**Review study on Commission
Regulation (EC) no 327/2011**
EVIA Comments to
VHK discussion document 21st Nov 2014

The European Ventilation Industry Association welcomes the VHK discussion document dated 21st November 2014 regarding the review of regulation 327/2011. We note that the consultant, on behalf of the Commission, has taken into consideration many of the problems, request and suggestions from the European Fan industry. The industry still has some concerns particularly with the proposed slopes and limits.

Graph of forward curved fans showing proposed new limit of N52 (static)

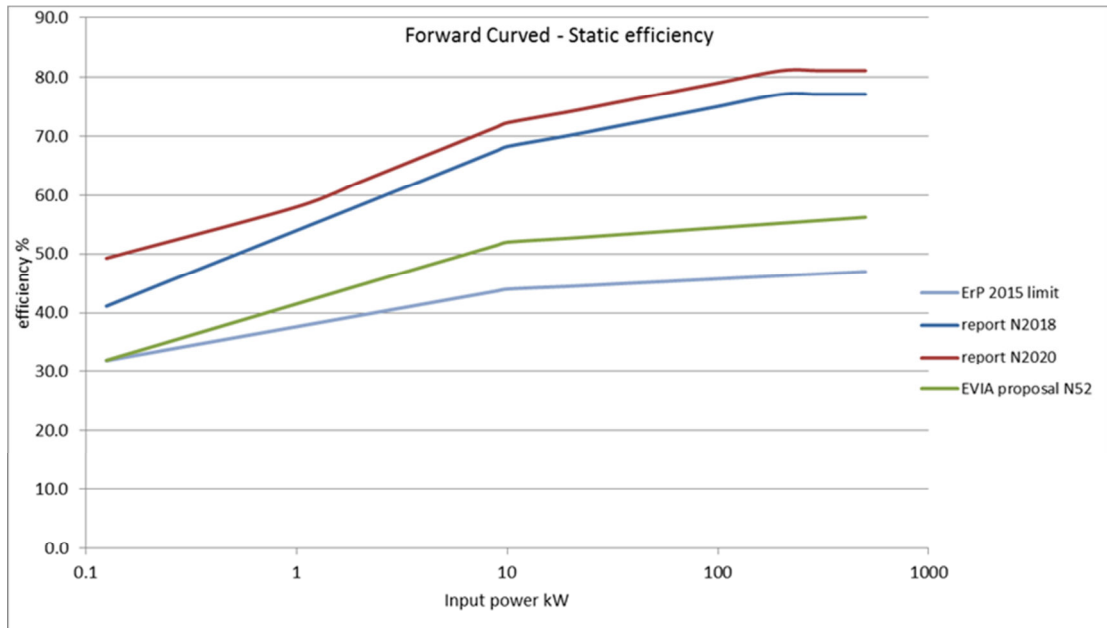
The proposed level for centrifugal fans will result in the removal of forward curved fans from the market. We do not agree with the statement that forward curved fans offer no unique qualities that cannot be reached with a backward curved fan. The forward curved fan has a higher power density and improved subjective acoustic characteristics and therefore demonstrates an environmental advantage over the backward curved centrifugal.

We suggest keeping a separate limit with a change of slope; e.g. use the backward curved slope and a level of N52 (static) for 2020. This has a small increase for the small fans and a large increase for 10kW and above. This recognises the unique high power density small forward curved fans provide the market place and the environment. The very high level of the slope at 10kW will remove the majority of forward curved fans and reflects the market place where these machines do not offer unique qualities over and above backward curves.

An interim slope for 2018 will be too great an impact on the industry. If these revisions come into force in 2016 then the industry will need at least three to four years to develop the technology.

The proposed slope is simpler than that proposed in this report and simplifies the current regulation as there will be only one slope for all fan types, just with different N values.

Graph of axial fans showing proposed new limit of N48 (static)

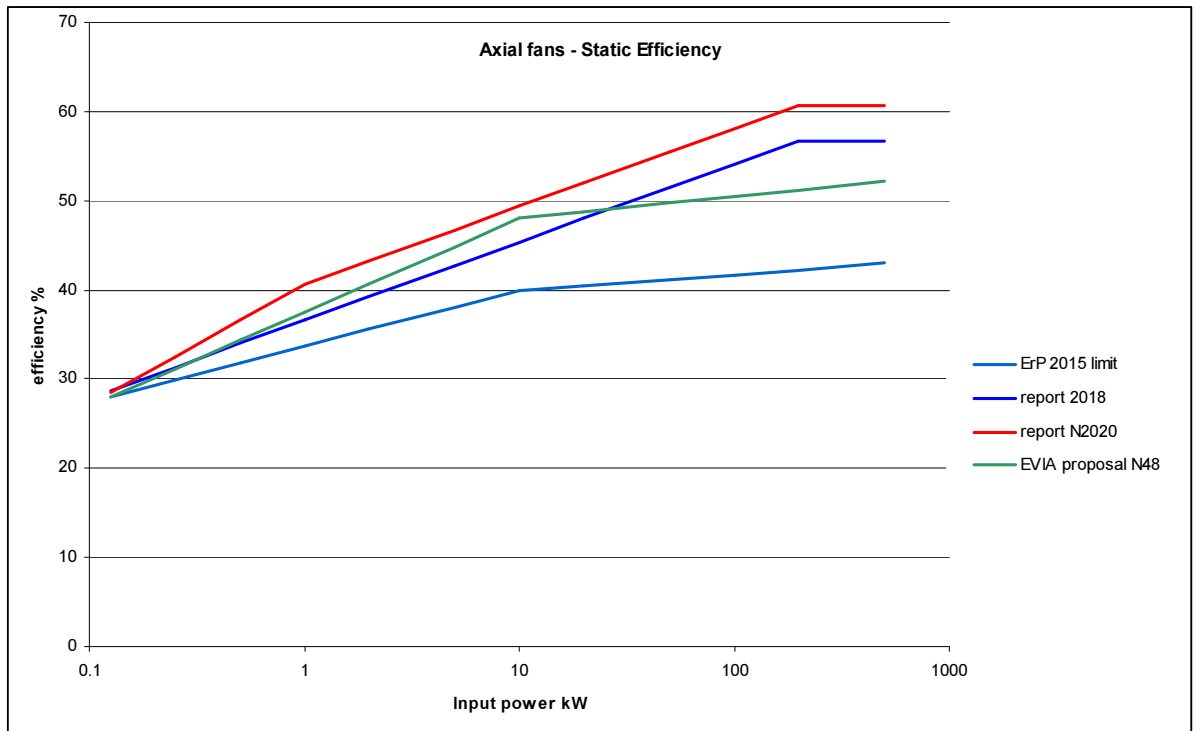
The proposed slope is much too high and would be a severe impact on the industry. We recognise there is room for improvement and propose the same slope as centrifugal fans with an N value of N48 (static) for 2020.

An interim slope for 2018 will be too great an impact on the industry. If these revisions come into force in 2016 then the industry will need at least three to four years to develop the technology.

We propose to use the same slope as the centrifugal and mixed flow fans of the current regulation i.e. $4.56 \cdot \ln(P) - 10.5 + N$ and $1.1 \cdot \ln(P) - 2.6 + N$. This will simplify current regulations resulting in one slope for all fans. It provides a simplification to the proposal in the report. It will deliver significant energy savings.

As previously stated, the difference between static and total limits of the current regulation is too great. The difference between the 2013 static and total limits was 14, which increased to 18 for 2015 and is unchanged in the discussion document proposal. The difference between the 2015 static and total limits for mixed flow is 12 and is reduced to 10 in the discussion document proposal. Similarly for centrifugal fans, the 2015 difference of 3 has been reduced to 2 for 2020. We agree that there should be a distinction between static and total values for axial fans, but this should be a maximum of 14.
